PETITION #2019-039
MALLARD CREEK NEIGHBORHOOD
CHARLOTTE, NORTH CAROLINA
DEPENDABLE DEVELOPMENT, INC.

Rezoning Transportation Analysis

Petition Number: 2019-039

DPR Response Letter: 2019-07-16

RZ-1

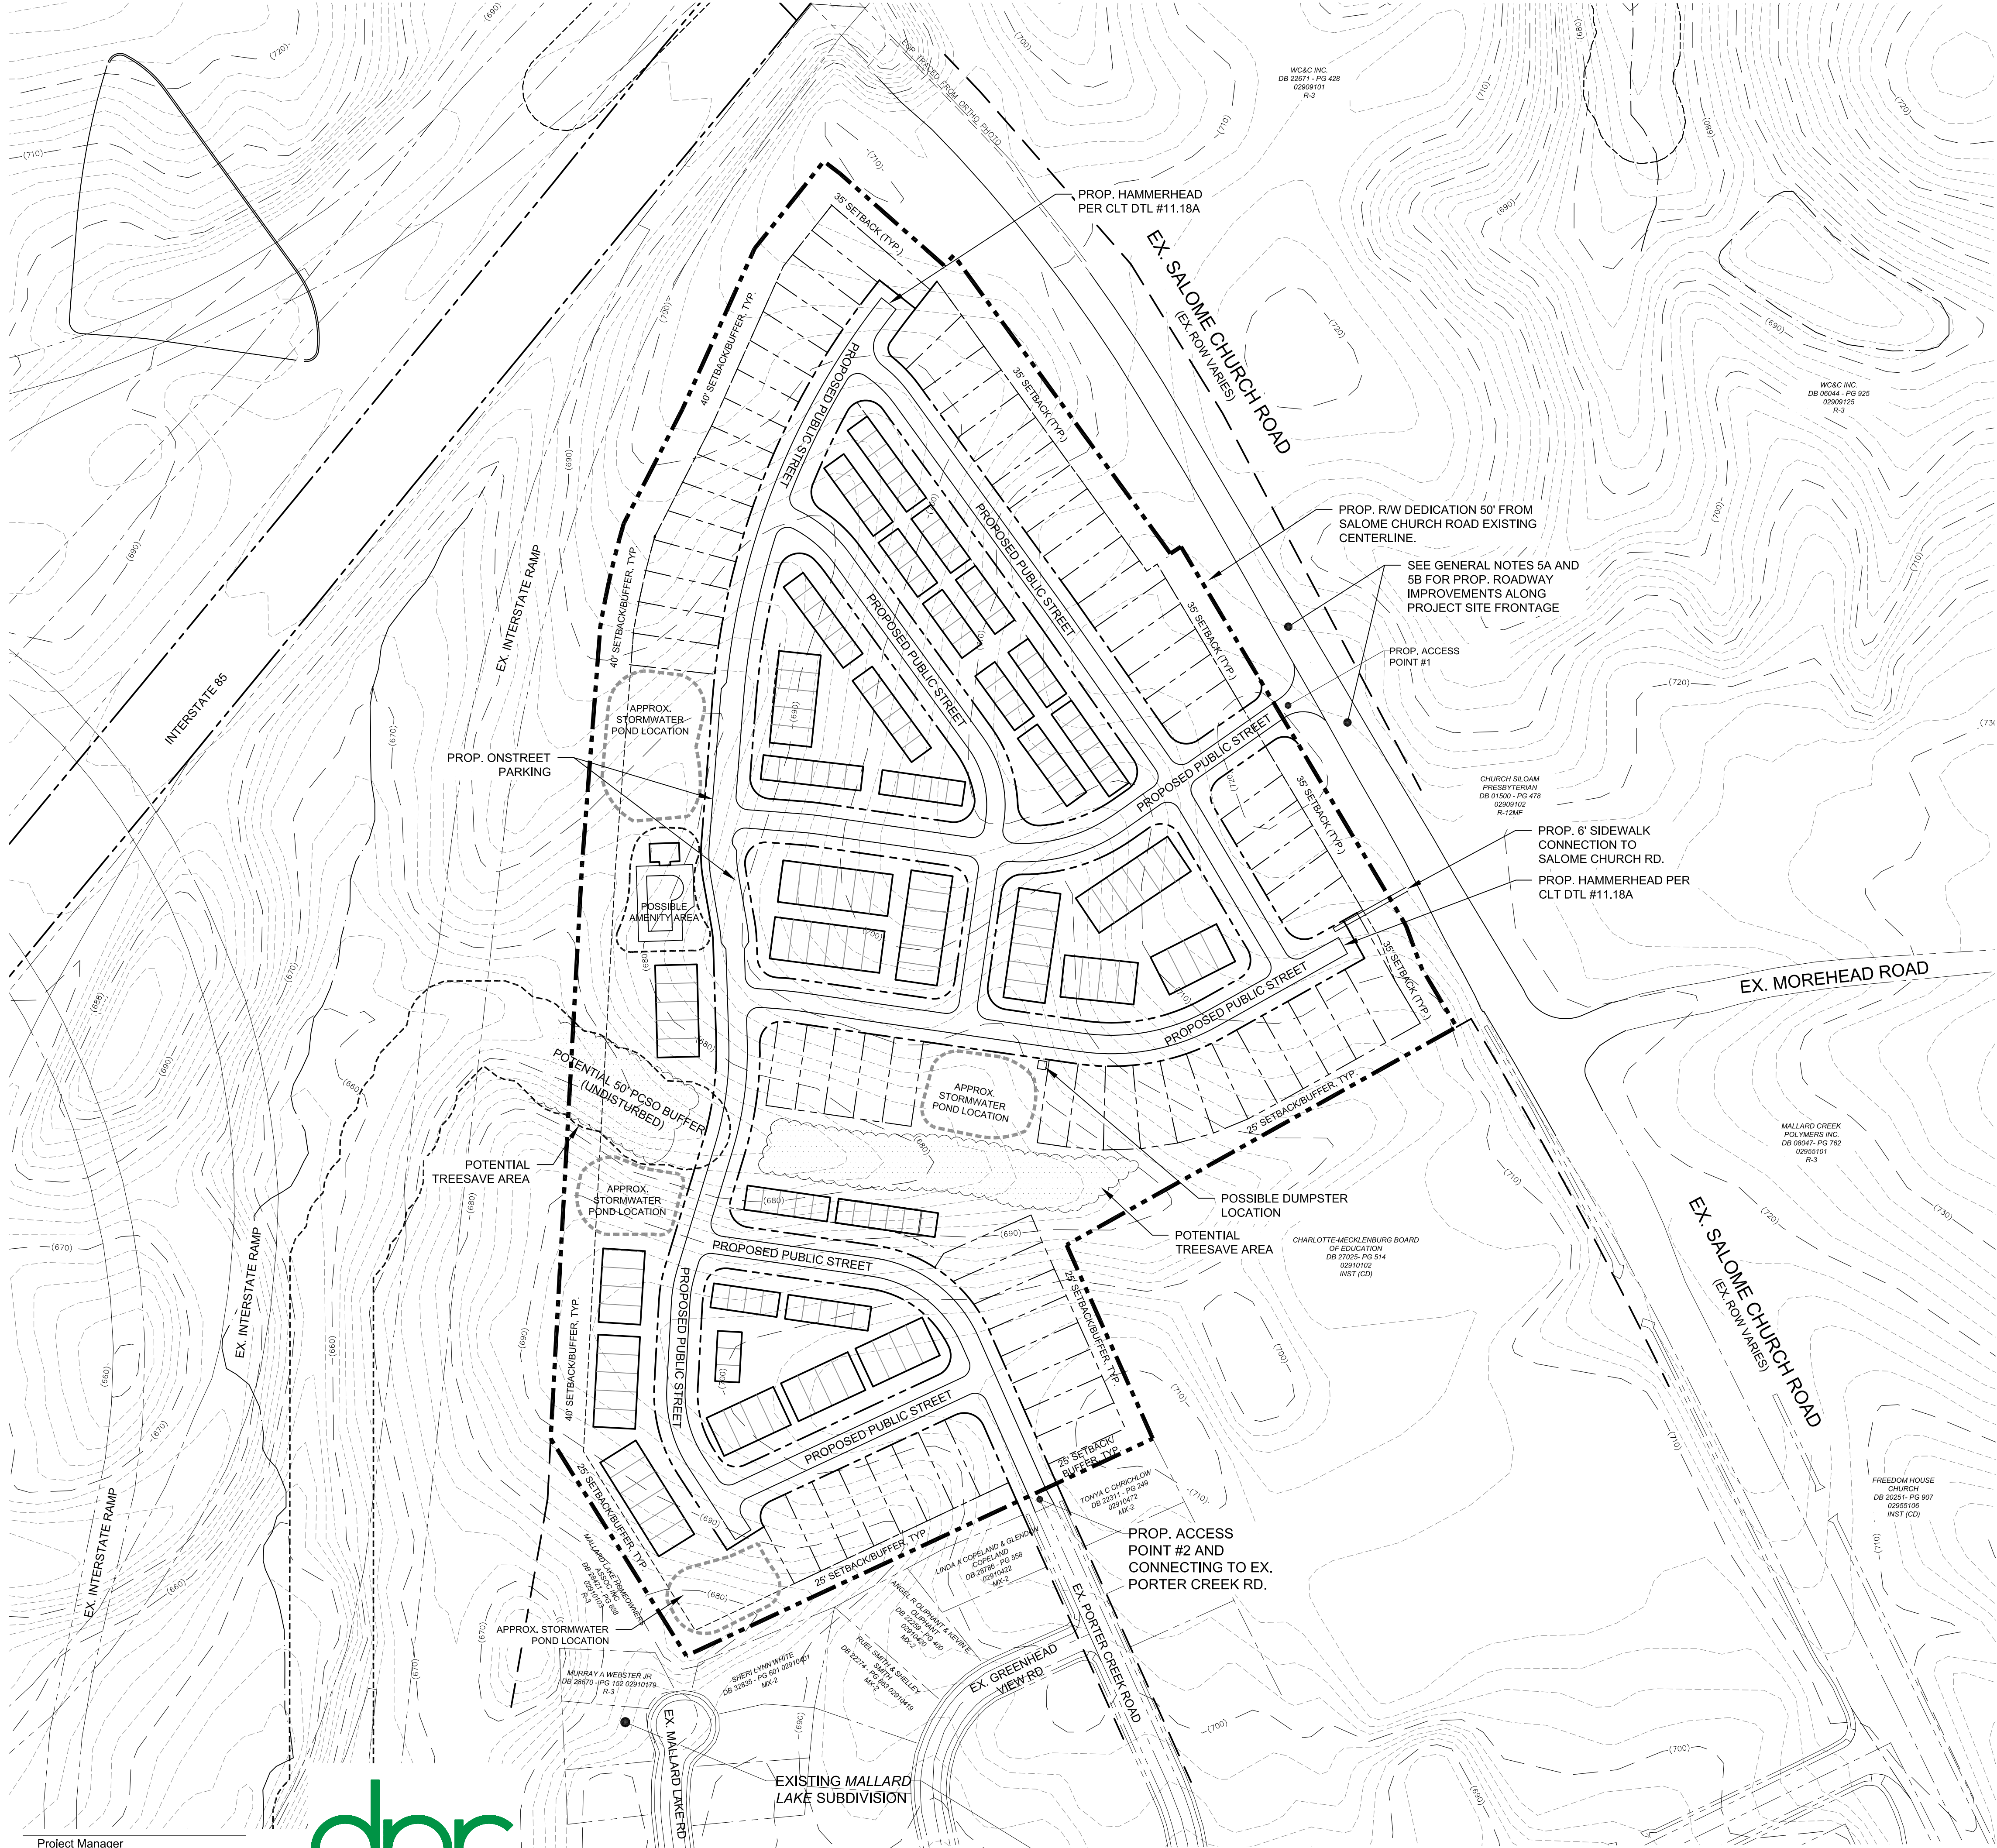
1. **Curbline:** The proposed zoning district has a setback measured from back of the existing or proposed future right-of-way line. The location of the future back-of-curb for:

- Salome Church Road – 30 feet as measured from the road's existing centerline. The petitioner should update the site plan to commit to construct the curb and gutter at the location mentioned above. The site plan should label and dimension the curb and gutter from the road centerline.

2. ~~**Traffic Study:** A Traffic Impact Study is not necessary for the complete review of this petition.~~
3. The petitioner should revise the site plan and conditional note(s) to specify and implement a 12' multi-use path, 8' planting strip, and 2.5' curb and gutter along the site's Salome Church Road frontage and extending to the I-85 bridge.

5. **Comment revised.** The petitioner should revise the site plan and conditional note(s) to commit to ~~asymmetric~~ **symmetric** off-site roadway improvements, to provide two 11' wide southbound travel lanes, **one north bound travel lane**, and a northbound 11' left turn lane on Salome Church Rd. at the proposed access location. The left turn lane should provide 100' of storage capacity and a 100' bay taper.

DPR Response: Done. See revised Note. We added "asymmetric or symmetric" per our agreement at the meeting w/ Rick, Eric.
6. ~~The petitioner should revise the site plan and conditional note(s) to include the proposed public street connection to existing Porter Creek Road.~~
7. **Comment revised.** The petitioner should revise the site plan and conditional note(s) to specify and provide an 8' planting strip and ~~(6')~~ 8' sidewalk throughout the entire subdivision. Also, the 8' planting strips and ~~(6')~~ sidewalks along the site's proposed southern public street need to be extend to Salome Church Rd's 12' multi-use path. ~~This pedestrian connection will provide a direct pedestrian/bike connection to Salome Church Rd. and provide pedestrian access to Stoney Creek Elementary.~~

DPR Response: Done. See revised Note.
8. ~~The petitioner should revise the site plan to add a note specifying dedication and fee simple conveyance of all rights of way to the City before the site's first building certificate of occupancy is issued. CDOT requests a sidewalk utility easement at 2' behind back of sidewalk.~~
9. **New Comment:** The petitioner should revise the site plan's note 5.B, to specify that all transportation improvements will be approved and constructed before the site's first building certificate of occupancy is issued.

DPR Response: Done. See revised Note. CDOT & Petitioner agreed on 40th Building CO.
10. ~~The petitioner should revise site plan note 5D to state the petitioner commits to implementing traffic calming measures, including three (3) speed humps, stop signs, and 25 mph speed limit signs within the subdivision. These devices will be funded by the petitioner and their placement will be determined during the permitting process.~~
11. ~~The petitioner should revise the site plan to implement on-street recessed parking on both sides of the proposed public street that fronts the possible amenity area. Accessible on-street parking spaces should also be provided on both sides of the proposed public street.~~
